Memo

Subject: The Village Precinct, Alphington

As requested, please find below comment on the concept plans submitted for the Village Precinct.

Heidelberg Road

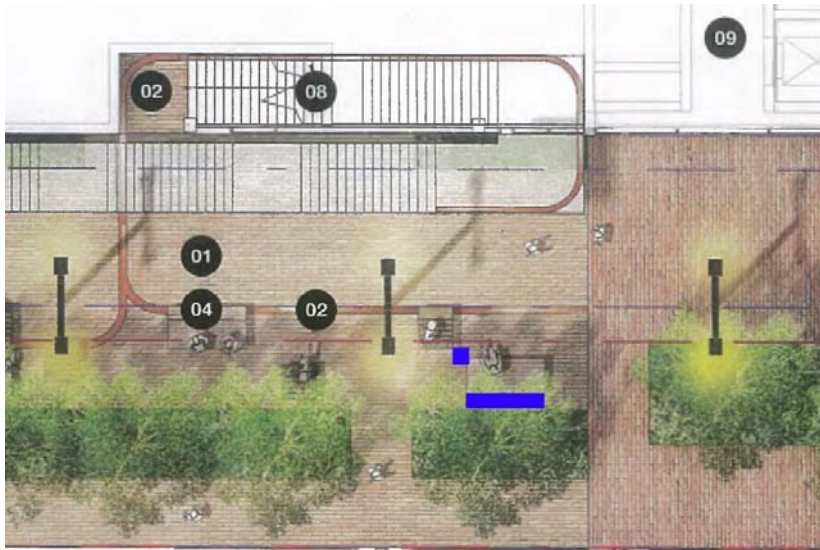
- A regular alignment of medium to large evergreen trees is supported.
- Clarification is required regarding the power line location – there are currently low and high voltage overhead power lines which restrict tree planting opportunities.
- The continuous planting strip is not supported. It would be preferable to provide seat and bike parking as necessary in the space between the street trees.
- Section 1 – More information is required on the extent of the steep gradient. If a retaining wall is required it is Council's preference that it be located at the kerbside edge to enable a continuous footpath space, improved tree planting conditions and improved access for tree maintenance.

Walls and edges selections

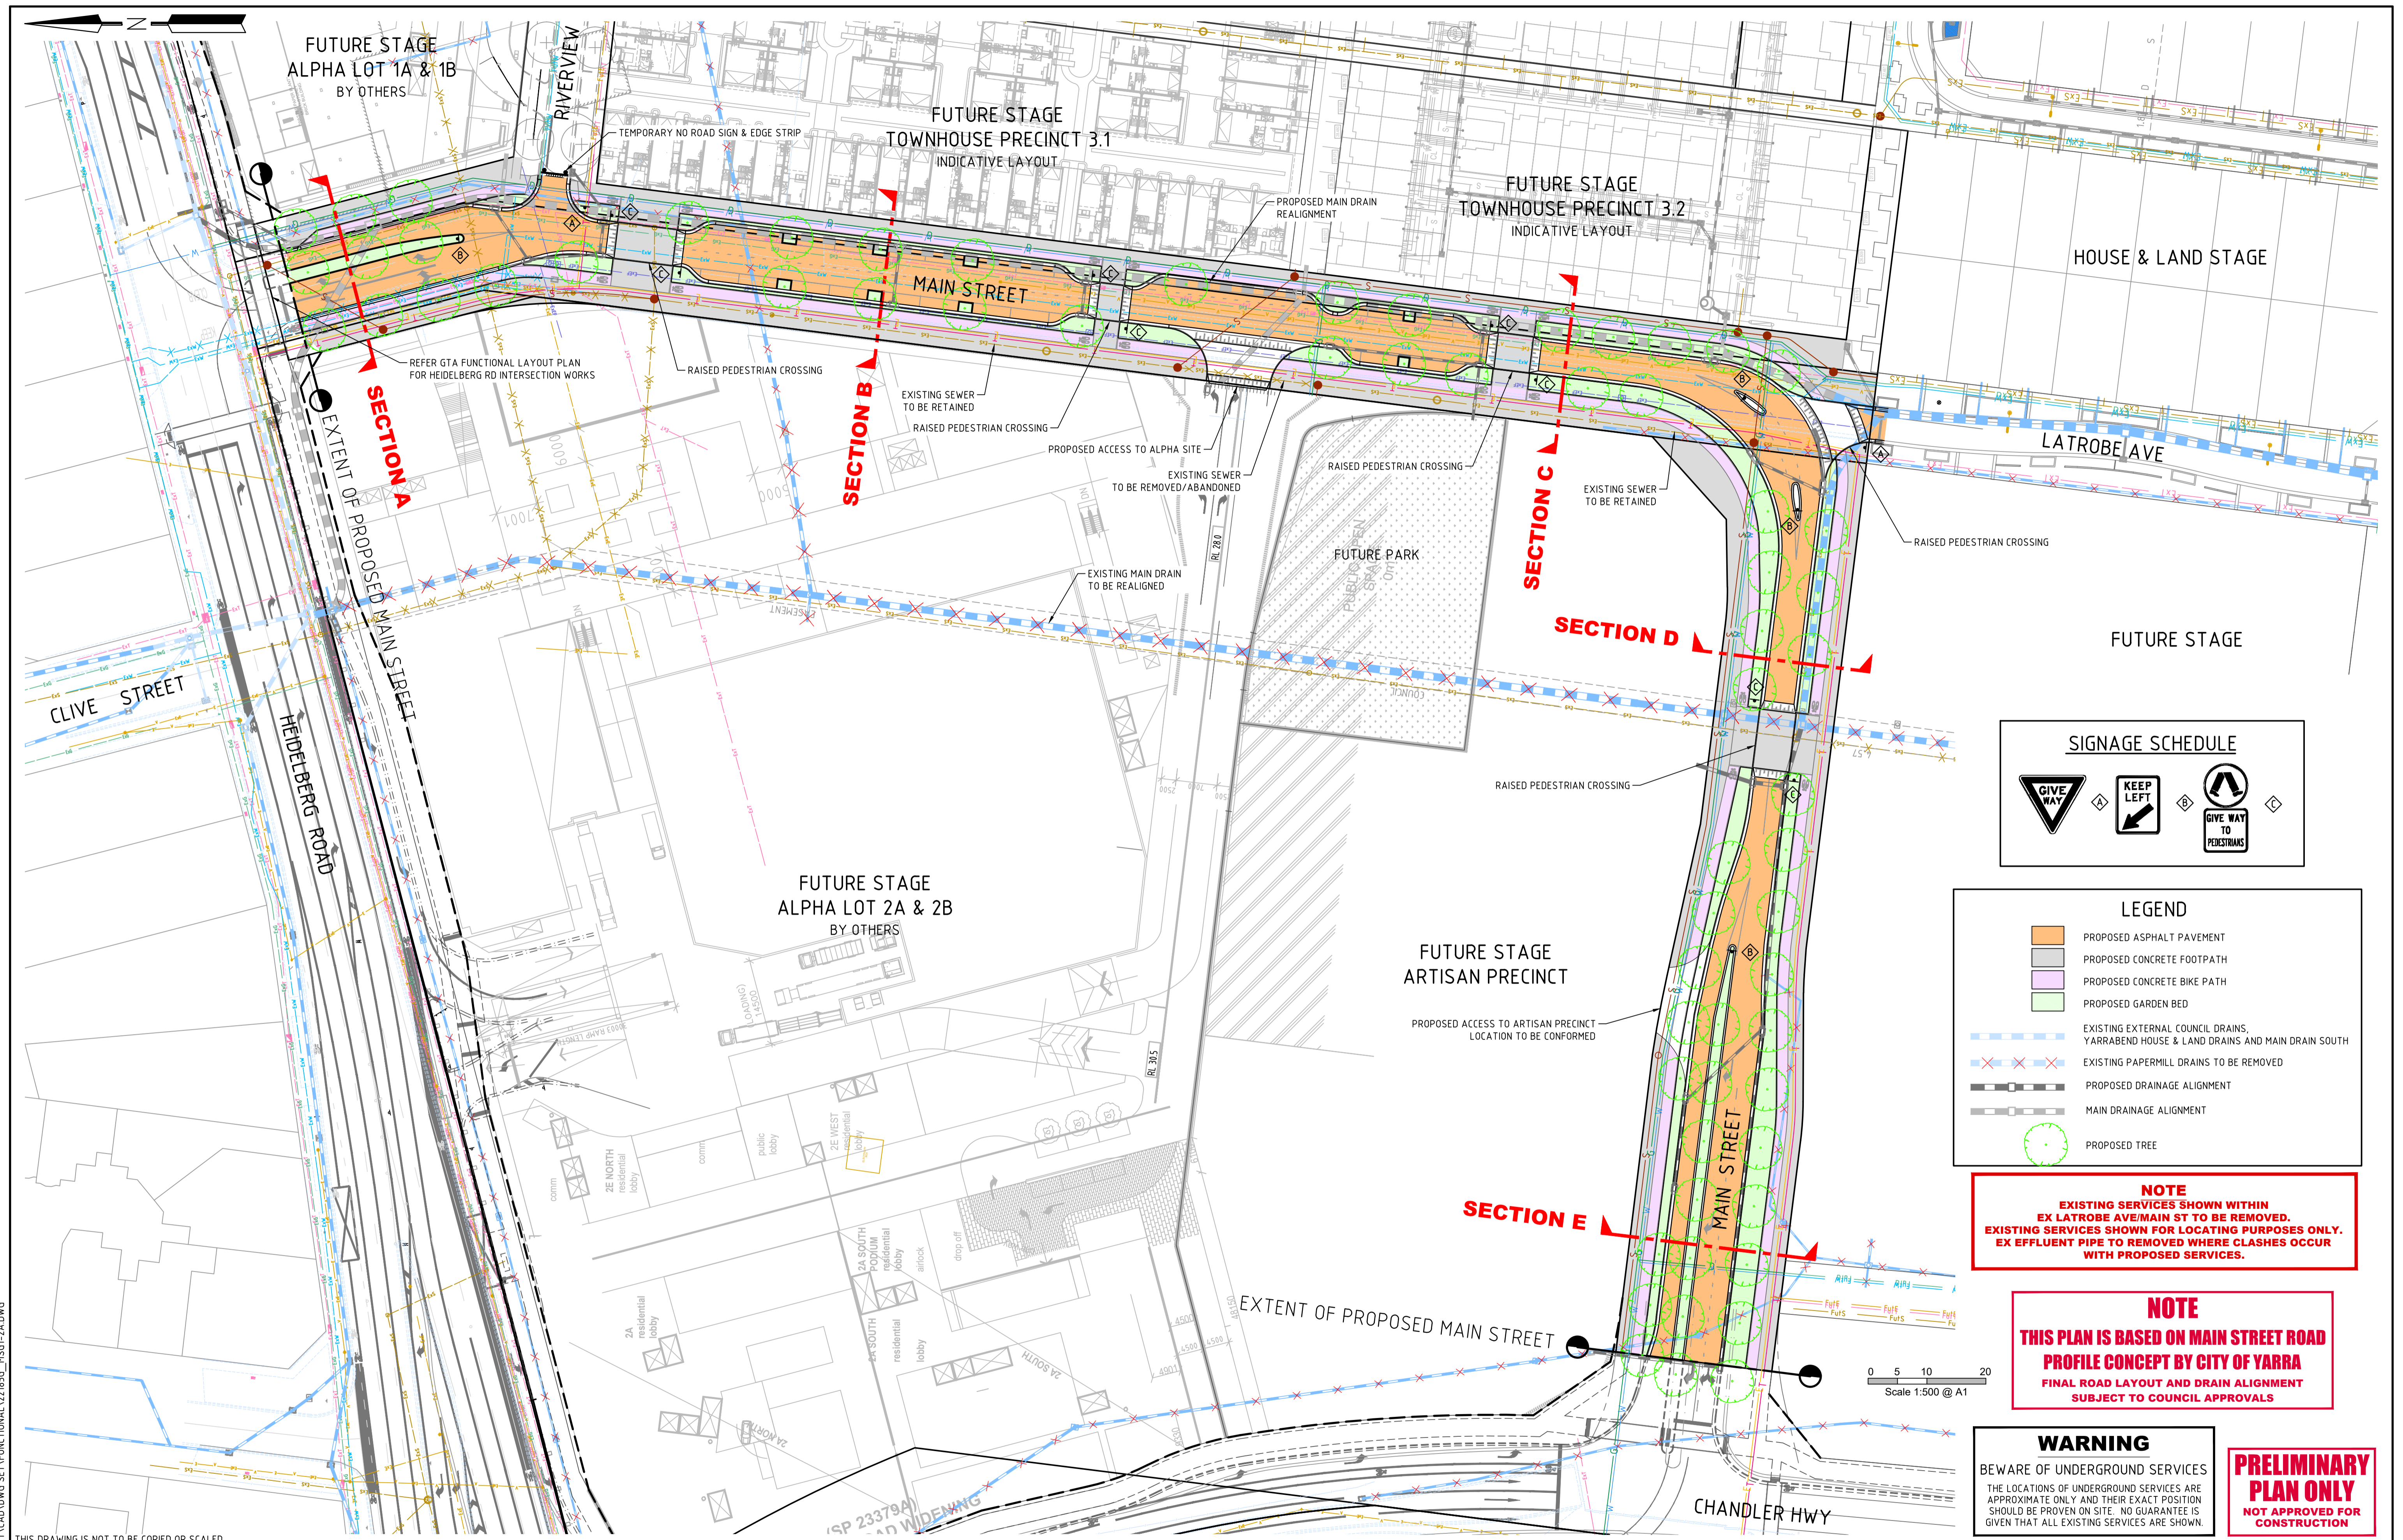
- Consider durability, maintenance and comfort (touch/ contact) when detailing steel walls, edges and inlays. Specify steel type, profile and finish.
- Confirm length of useable seating height for precast concrete walls on La Trobe Avenue. (Min-max heights)

GRADING 01
REVISED GRADING APPROACH

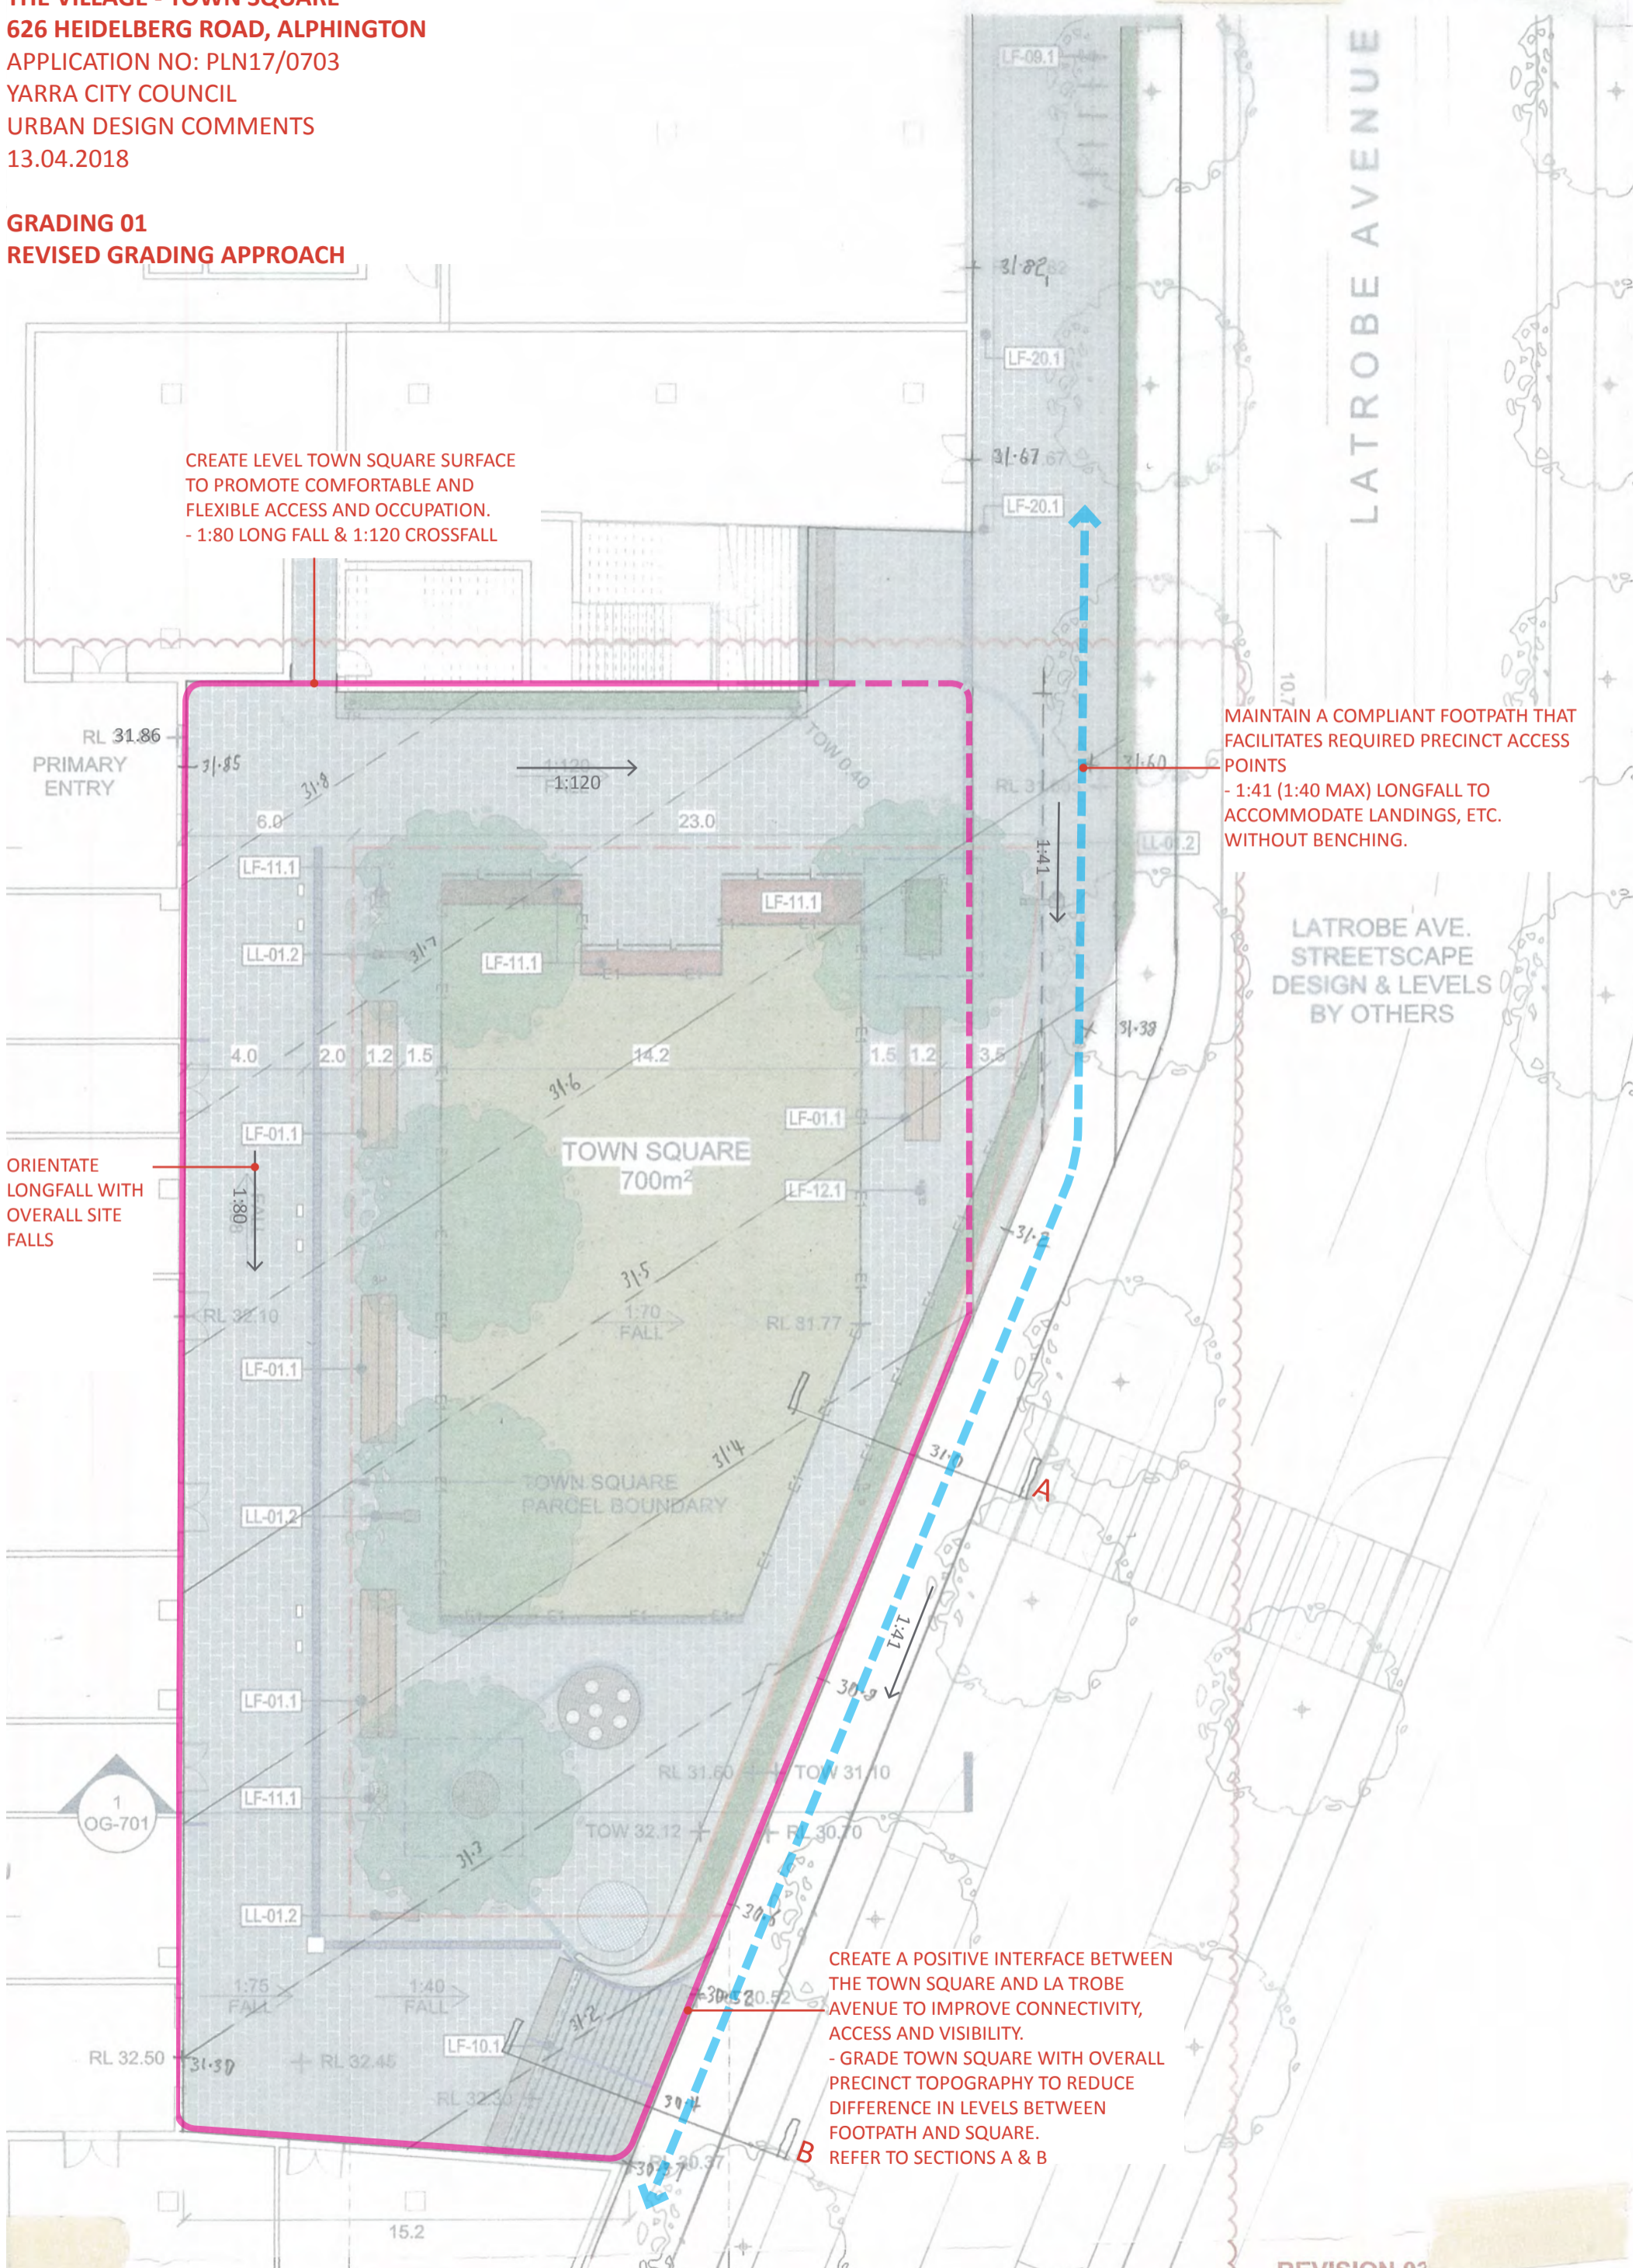
Grading Approach (Refer to attached Grading sketches 01 & 02)

- Create level Town Square surface to promote comfortable and flexible access and occupation (suggest 1:80 long fall & 1:120 crossfall)
- Further co-ordination is required to resolve interface between Village Square and La Trobe Avenue. Intent is to maintain a compliant footpath that facilitates all required access without localised benching - 1:41 (1:40 max) longfall to accommodate landings, etc. without benching.

- Create a positive interface between the Town Square and La Trobe Avenue to improve connectivity, access and visibility. The proposed plaza grades and edge treatment obscure views into the square from southern approach and a significant length of La Trobe Avenue footpath - Grade Town Square with overall precinct topography to reduce difference in levels between footpath and square.

CREATE LEVEL TOWN SQUARE SURFACE TO PROMOTE COMFORTABLE AND FLEXIBLE ACCESS AND OCCUPATION.
- 1:80 LONG FALL & 1:120 CROSSFALL

MAINTAIN A COMPLIANT FOOTPATH THAT FACILITATES REQUIRED PRECINCT ACCESS POINTS
- 1:41 (1:40 MAX) LONGFALL TO ACCOMMODATE LANDINGS, ETC. WITHOUT BENCHING.

ORIENTATE LONGFALL WITH OVERALL SITE FALLS

CREATE A POSITIVE INTERFACE BETWEEN THE TOWN SQUARE AND LA TROBE AVENUE TO IMPROVE CONNECTIVITY, ACCESS AND VISIBILITY.
- GRADE TOWN SQUARE WITH OVERALL PRECINCT TOPOGRAPHY TO REDUCE DIFFERENCE IN LEVELS BETWEEN FOOTPATH AND SQUARE.
REFER TO SECTIONS A & B
